# CITY OF ALBUQUERQUE

**RE: Circle K – 9610 Eagle Ranch Rd. NW**  
**Temporary Certificate of Occupancy**  
**Engineer's Certification Date: 06/24/2025**  
**Engineer's Stamp Date: 12/22/23**  
**Hydrology File: C13D028**  
**Case # HYDR-2025-00224**

STORMWATER  
QUALITY POND  
PLAN & PROFILE

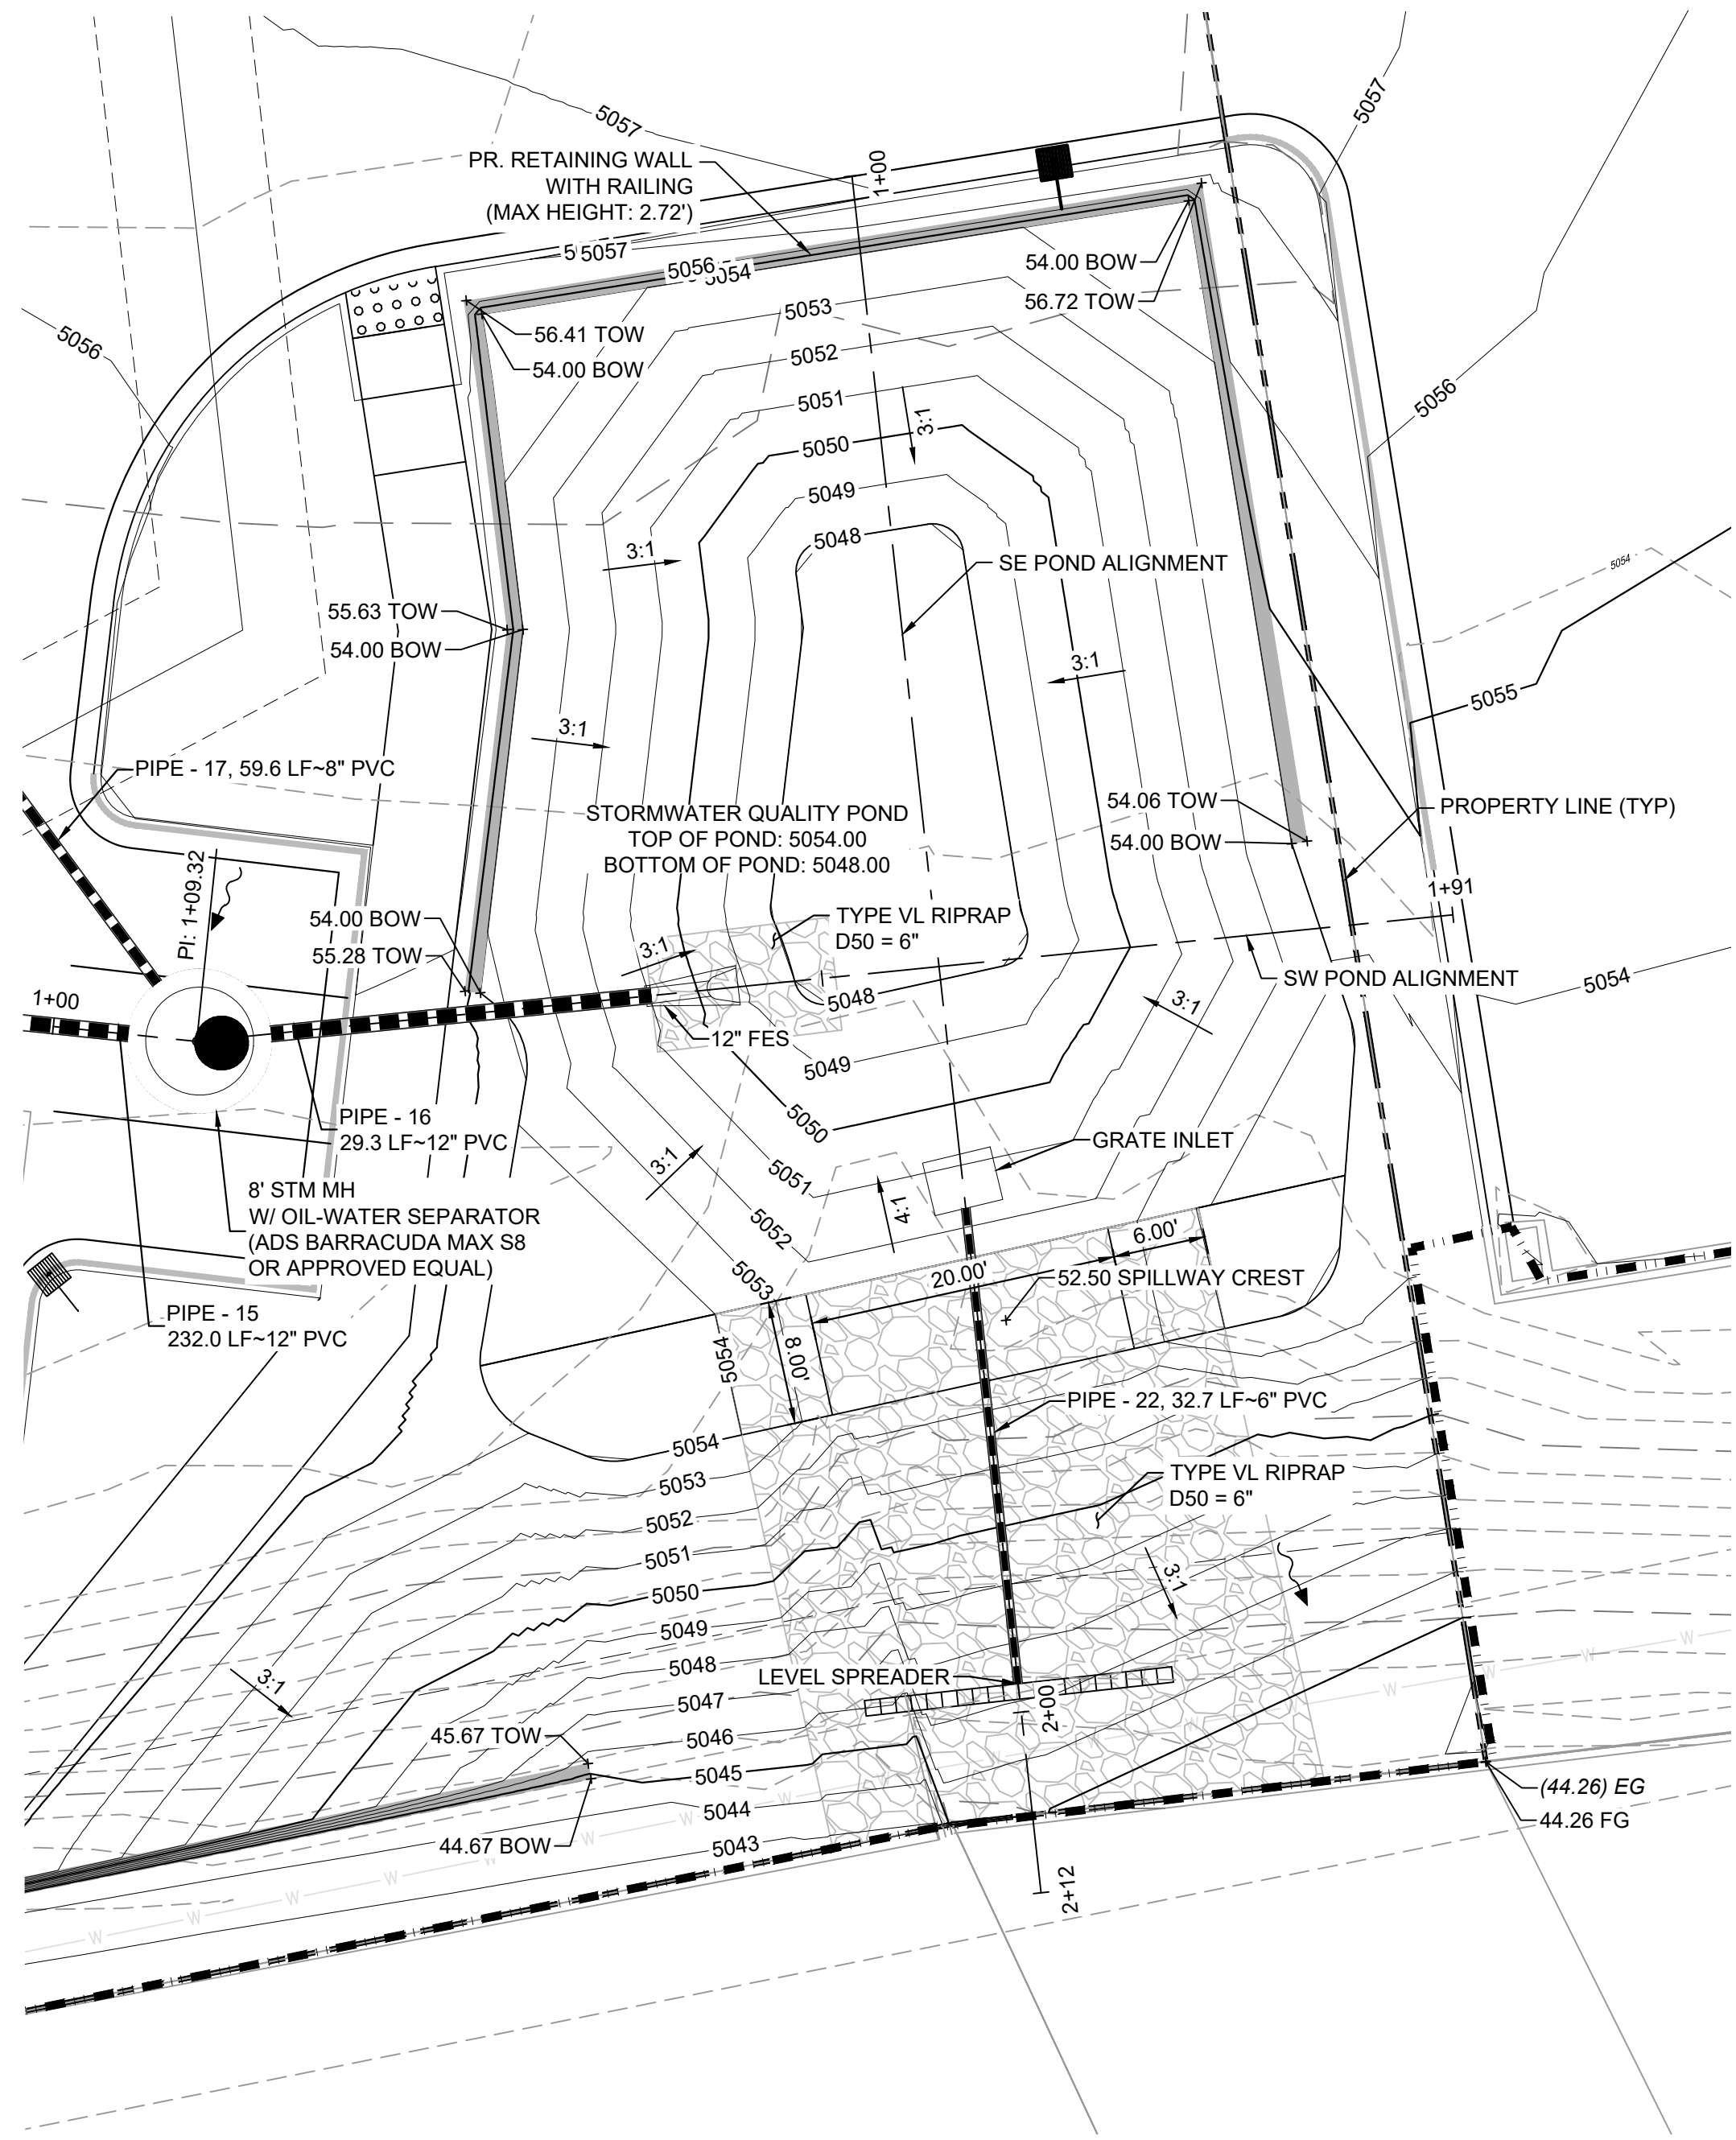
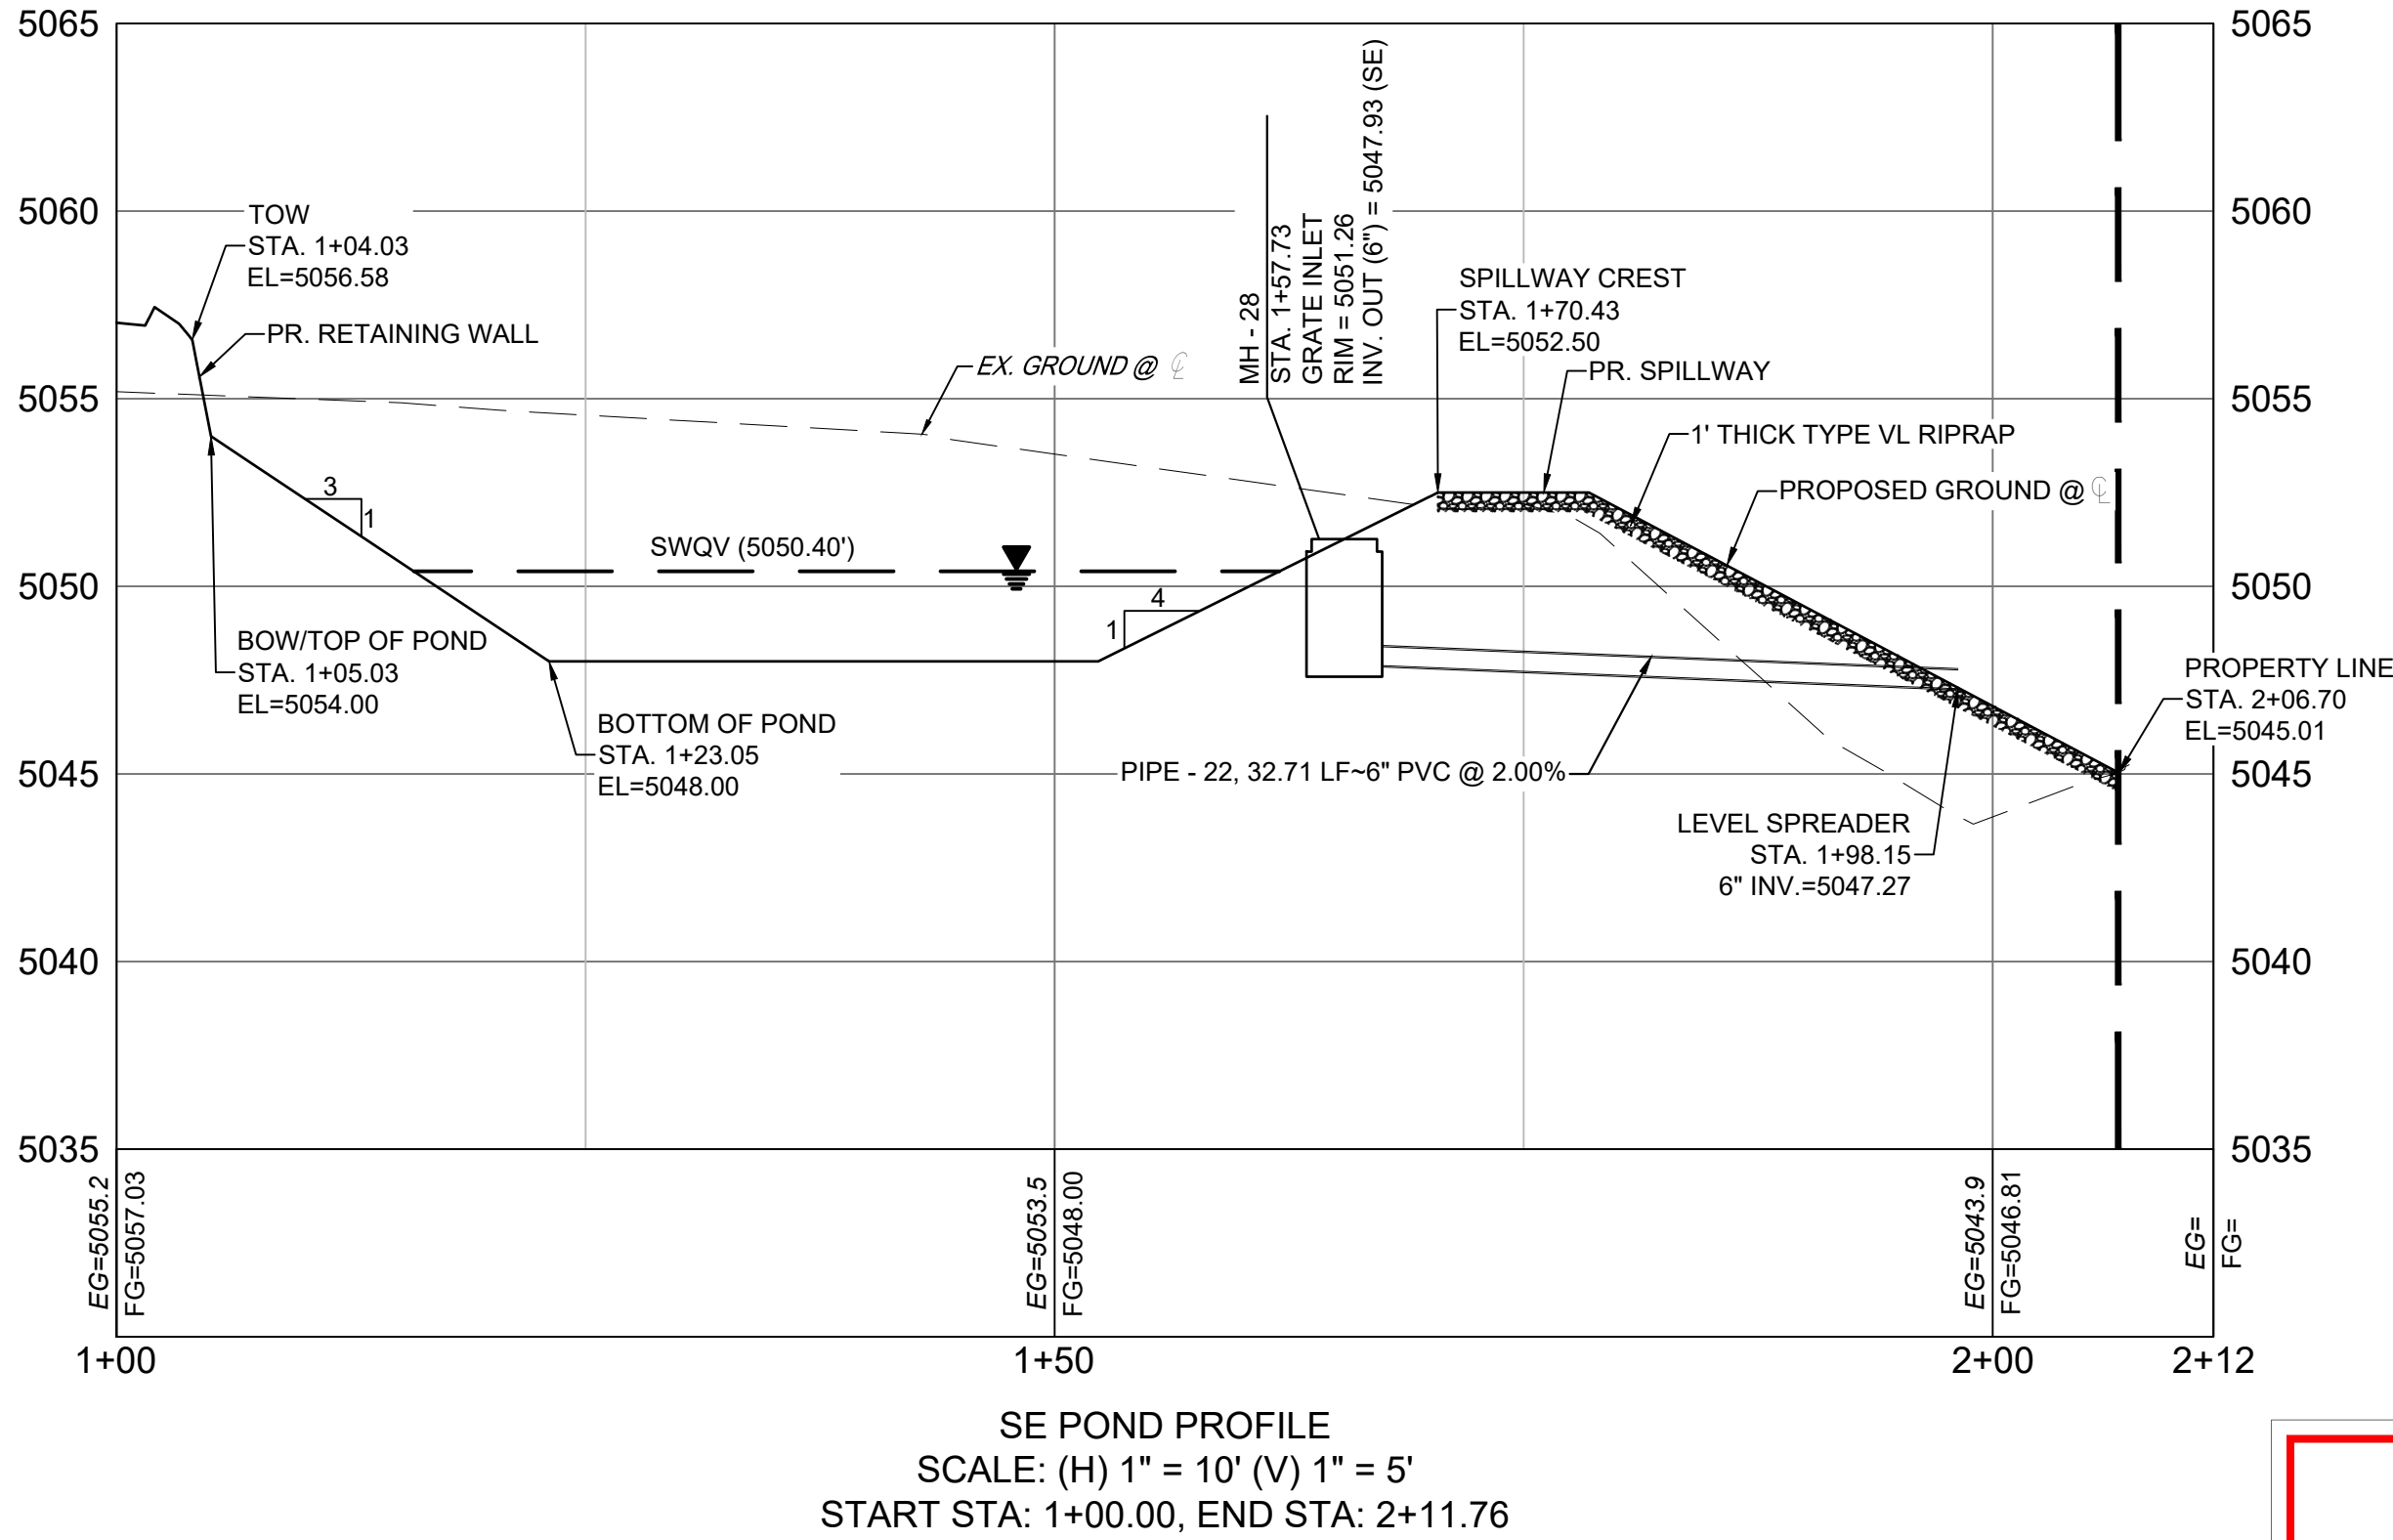
1. Complete the slope stabilization and erosion control needed for the east side of the lot.
2. Please provide the Drainage Covenant with Exhibit A for the stormwater quality pond per Article 6-15(C) of the DPM prior to Permanent Release of Occupancy. Please submit the original copies along with the **\$ 25.00** recording fee check made payable to Bernalillo County to Hydrology. In order to submit the DC, you will need to apply in ABQ-PLAN for a Covenant and upload the Drainage Covenant and Exhibit A (separate attachments). Then the originals and the filing fee are turned in to Hydrology for processing.
